McCune Ranch Subdivision
17480 Meridian Road North
Colorado Springs, Colorado 80924

Preliminary Drainage Report

OCTOBER 12, 2018

MATCH LINE - SEE SHEET C2.3 - PROPOSED DRAINAGE PLAN - SOUTH

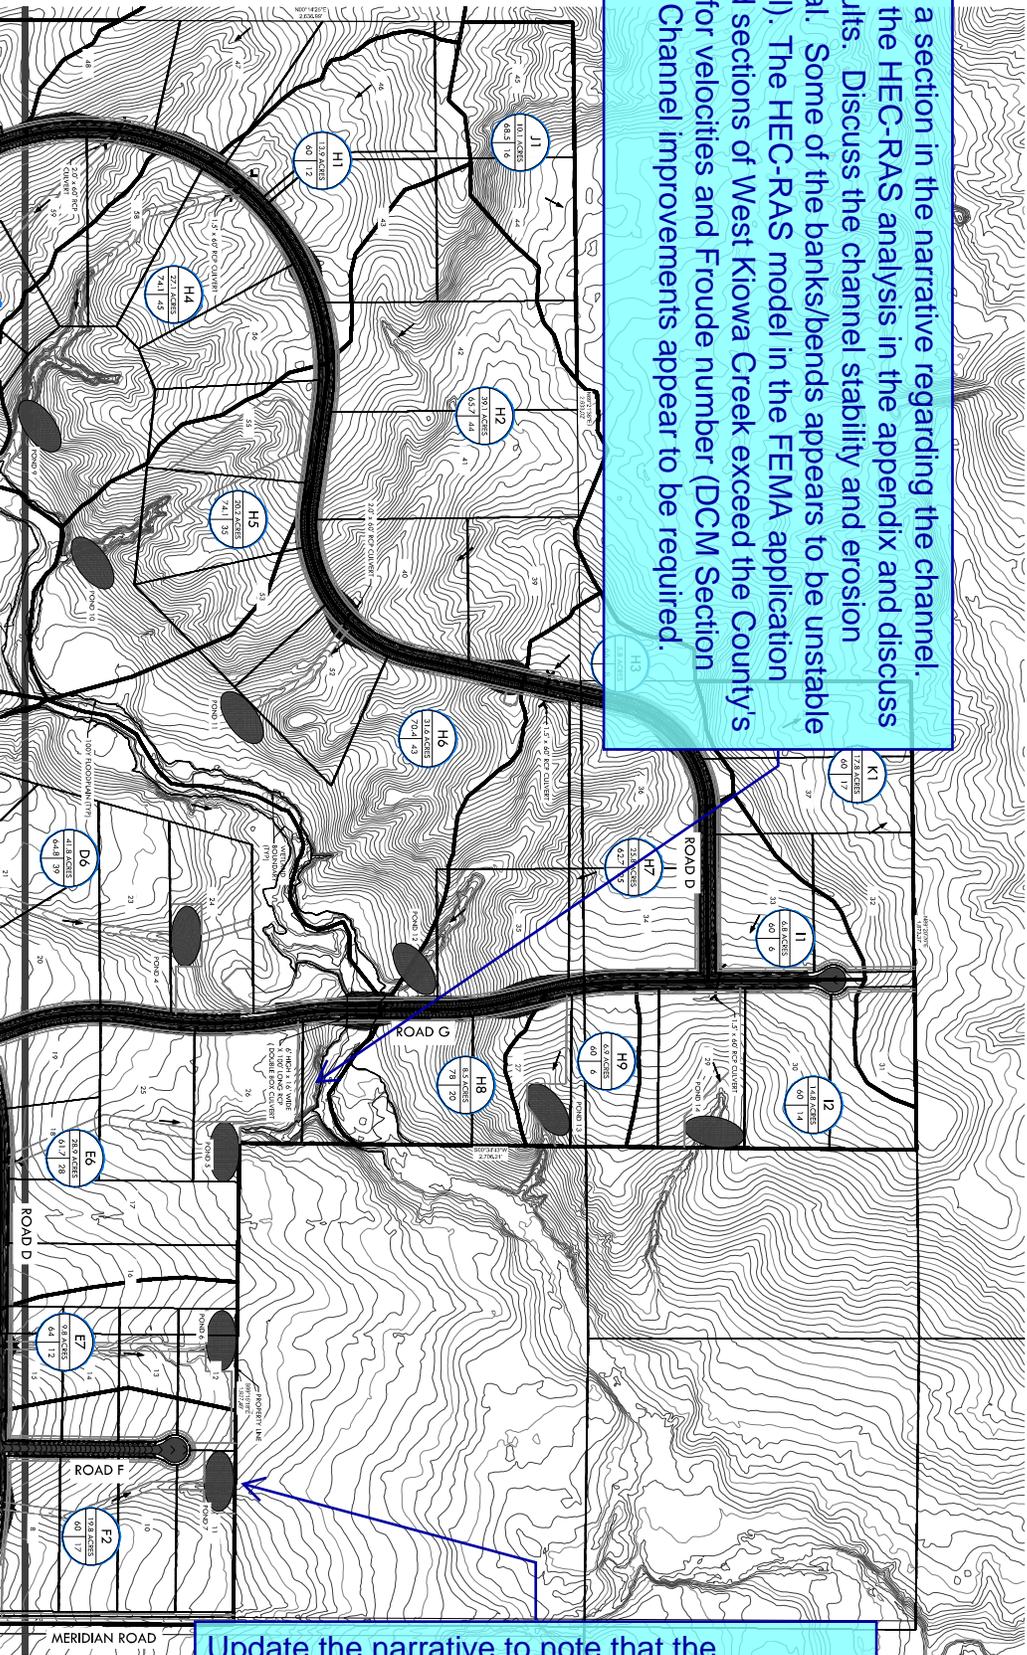
Include a section in the narrative regarding the channel. Include the HEC-RAS analysis in the appendix and discuss the results. Discuss the channel stability and erosion potential. Some of the banks/bends appears to be unstable (vertical). The HEC-RAS model in the FEMA application showed sections of West Kiowa Creek exceed the County's criteria for velocities and Froude number (DCM Section 6.5.2). Channel improvements appear to be required.

Revise the 100yr delineation. The line type used is too similar to the contours.

FYI: Roadside ditch analysis will be required with each final drainage report. Part of the analysis will need to identify the lots that will need driveway culverts greater than the standard 18" dia. and identify the required culvert size.

PROPOSED DRAINAGE PLAN - SOUTH
 SITE: 17480 MERIDIAN ROAD
 ELBERT, COLORADO 80106
 FOR: PT MCCUNE, LLC
 1864 WOODMORE DR, SUITE 100
 MONUMENT, COLORADO 80132

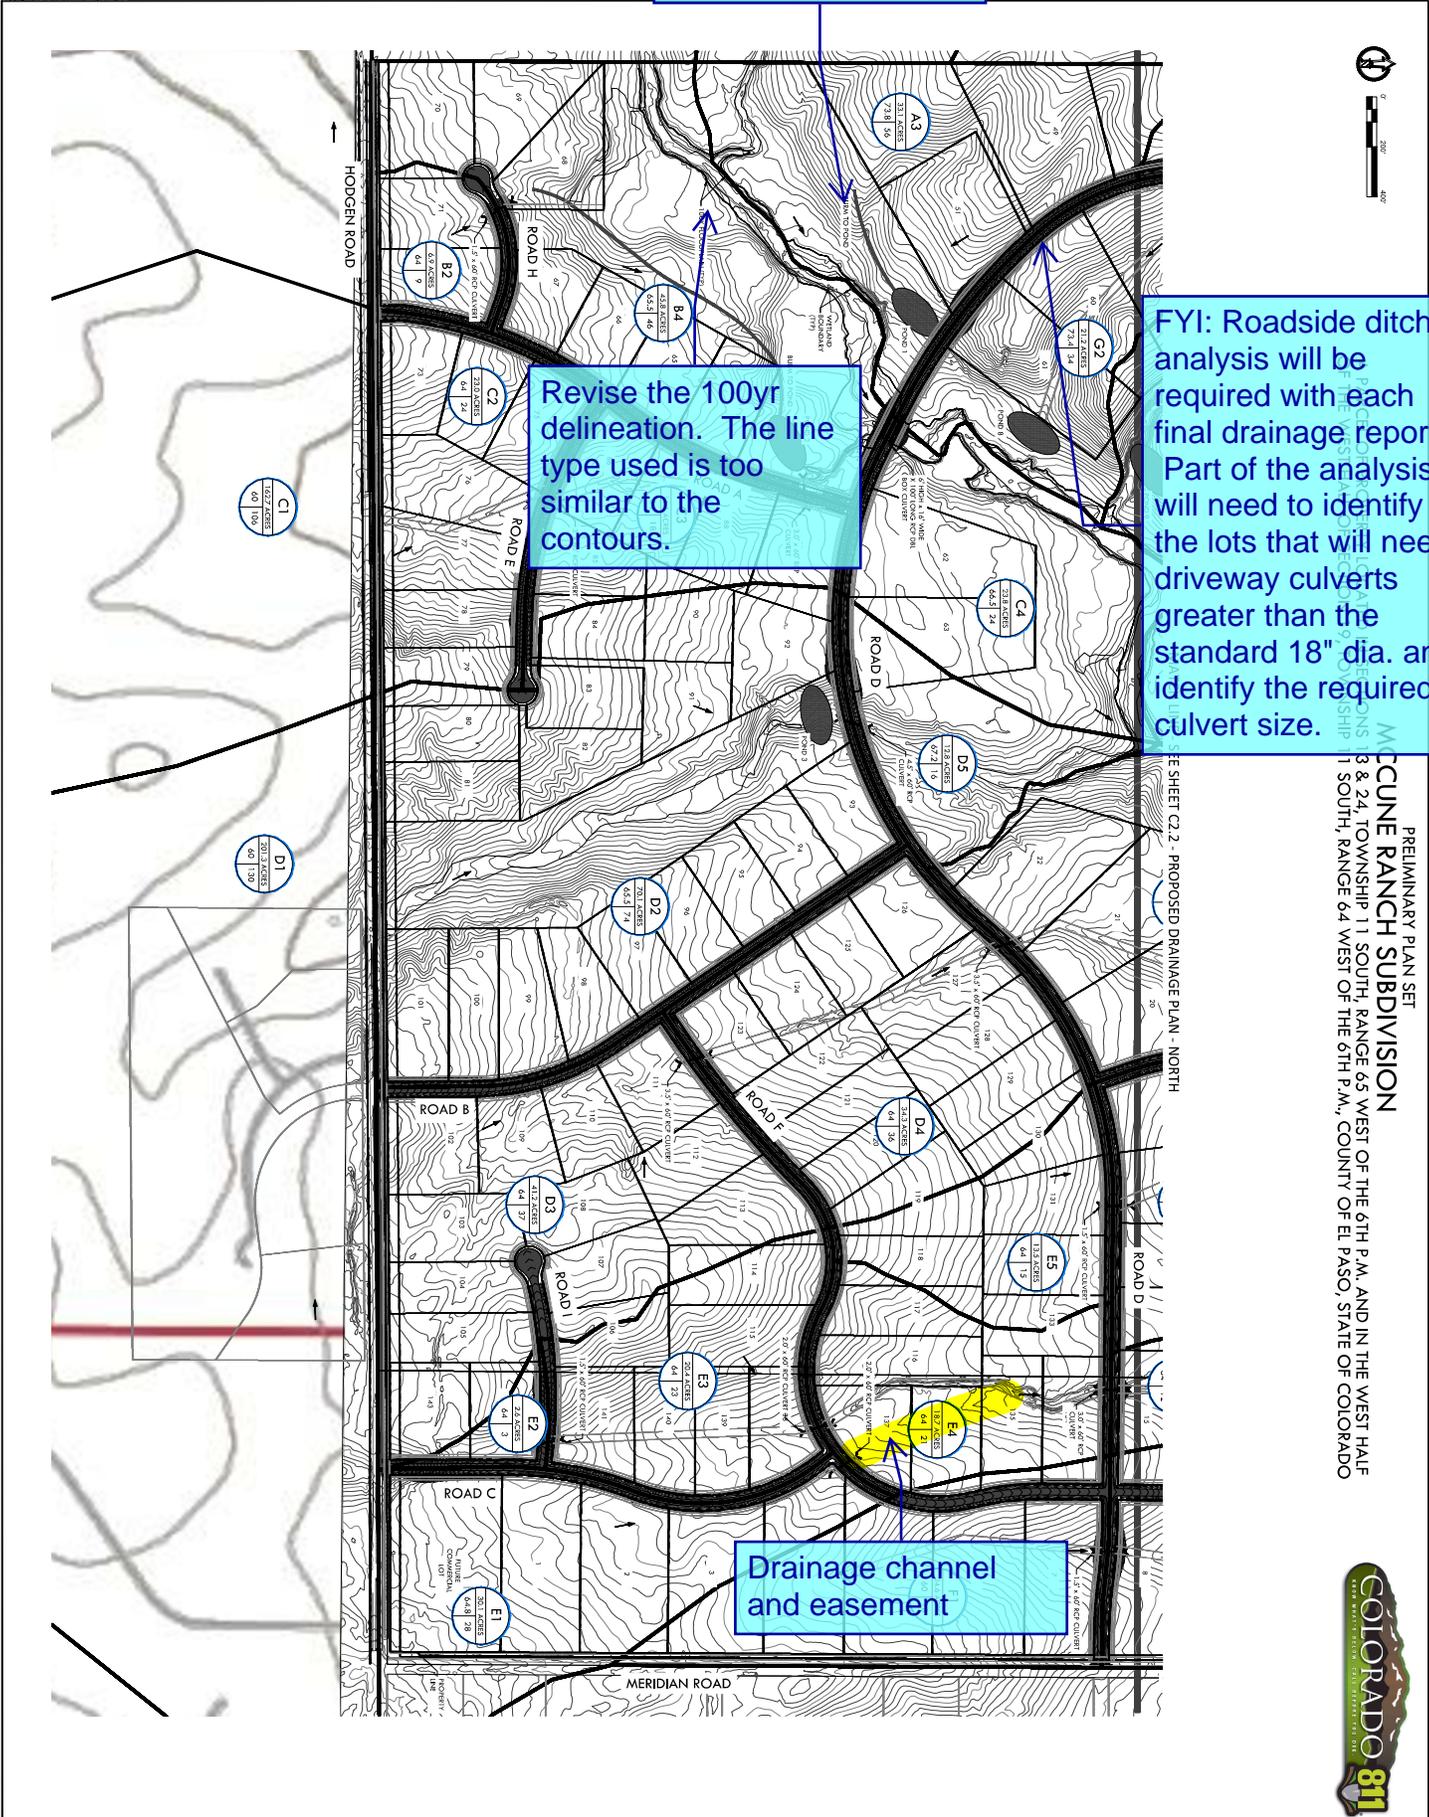
Drainage channel and easement
